**RE: Lot 3 Block 4 Unit 18, S.A.D. 228
Volcano Cliffs Subdivision
6612 Papagayo St.. NW
Grading and Drainage Plan
Engineers Stamp Date 5/19/2021
Pad Cert Date: 2/21/2022 (D10D003J3)
Revised Pad Cert for Pool: 2/24/2022**

**RE: Lot 3 Block 4 Unit 18, S.A.D. 228
Volcano Cliffs Subdivision
6612 Papagayo St. NW
Grading and Drainage Plan
Engineers Stamp Date 5/19/2021
Pad Certification Date: 2/21/2022
Rev_BP_for_Pool, 2/22/2022 (D10D003J3)**

CANDELARIA HOMES (TEDSTROM) - G & D PLAN

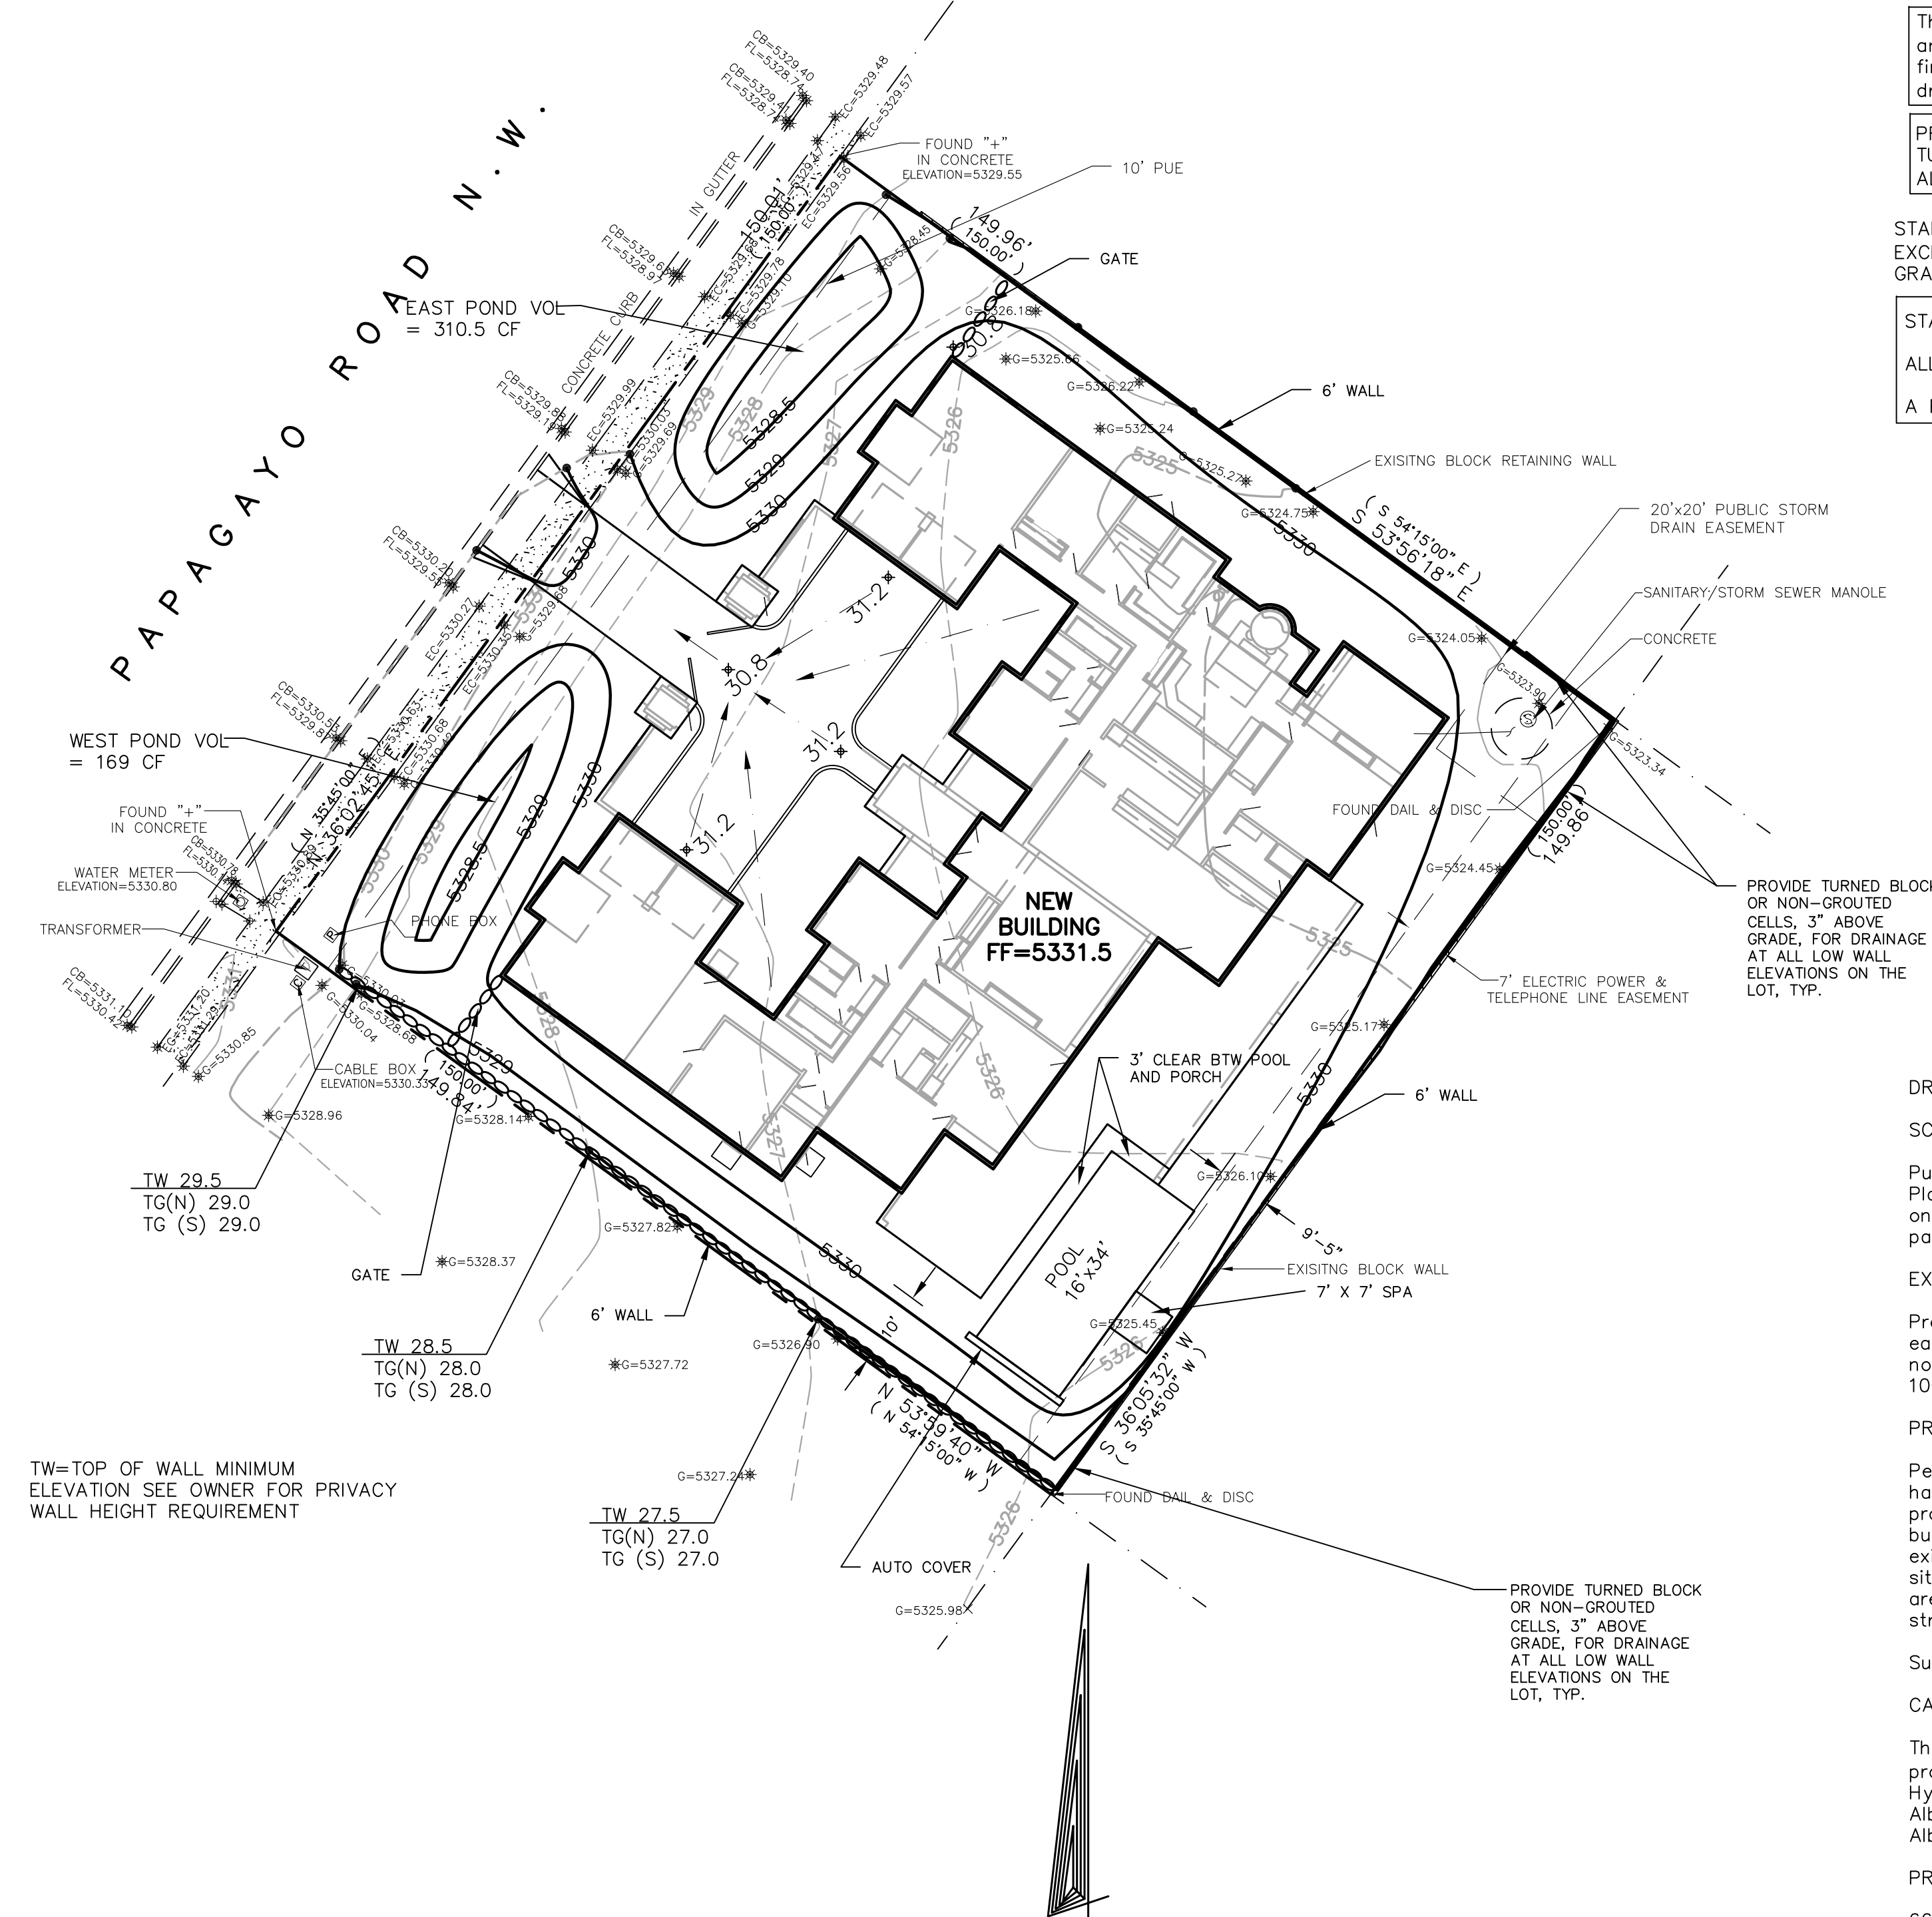
- Provide the new land treatments for the addition of the pool, impervious area has increased. Do not cover land treatment values with pad cert language.

New land treatments have been provided. Most of the pool area replaced an area that was previously designated as covered porch, therefore the increase in impervious area was only 241 sf, or 0.005 ac.
